Product Change Notice

Issue Date: 19-January-2021

New dice replacement for seven segment display

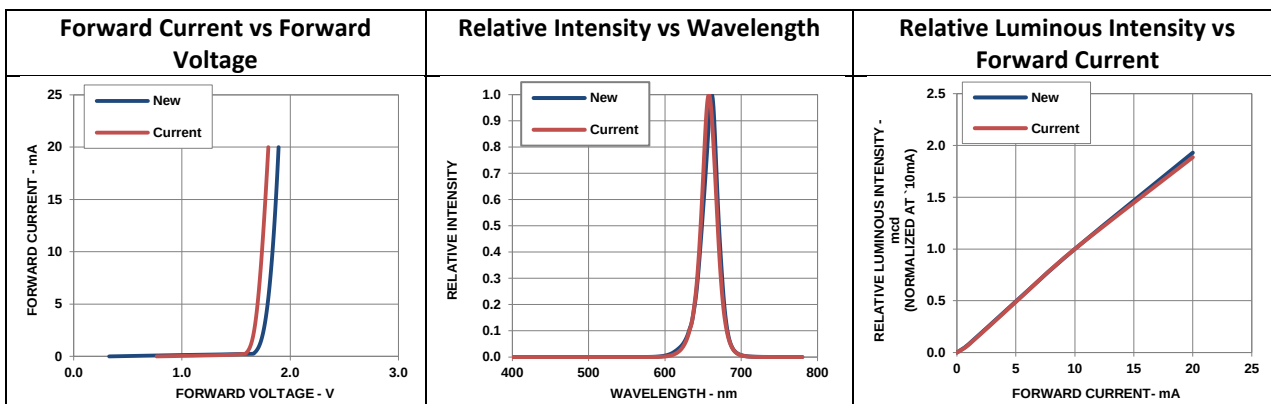
The new dice (AlInGaP) shall be replacing current dice (AlGaAs) for part number above.

Obsolescence of current dice by dice supplier.

Effect of Change on Fit, Form, Function, Quality, or Reliability:

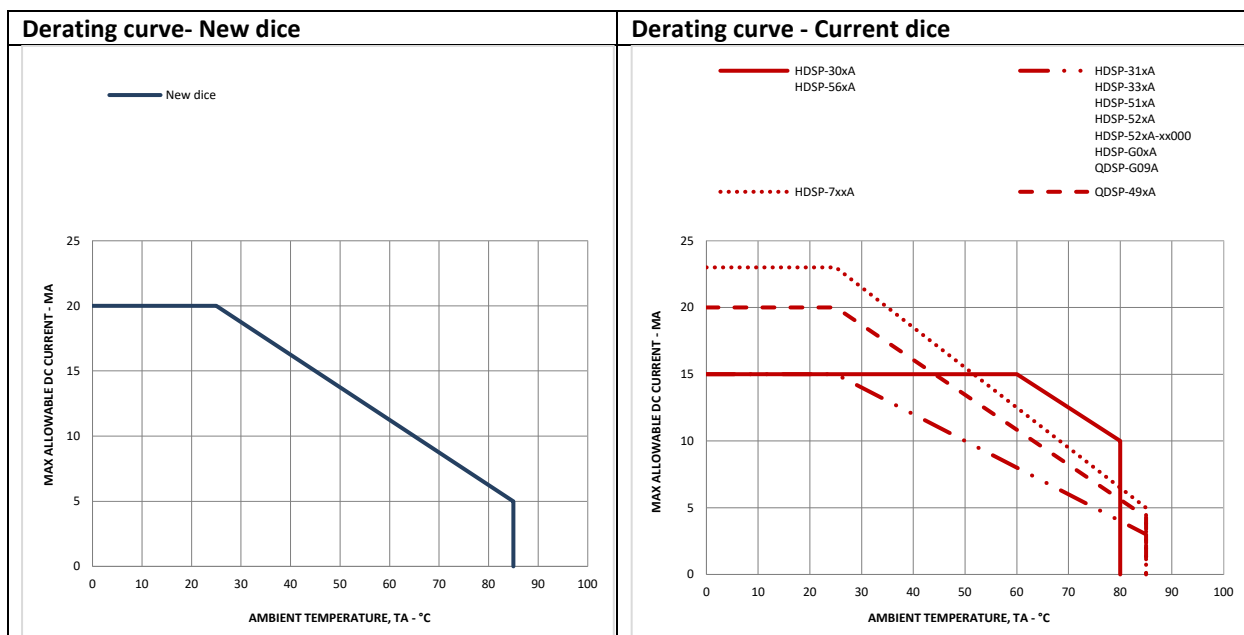
There is no change in fit and form of the product as per datasheet.

The storage temperature & operating temperature range will be standardized to -40°C/85°C.

Below are the comparison of the Electrical / Optical characteristic between the current & new dice:
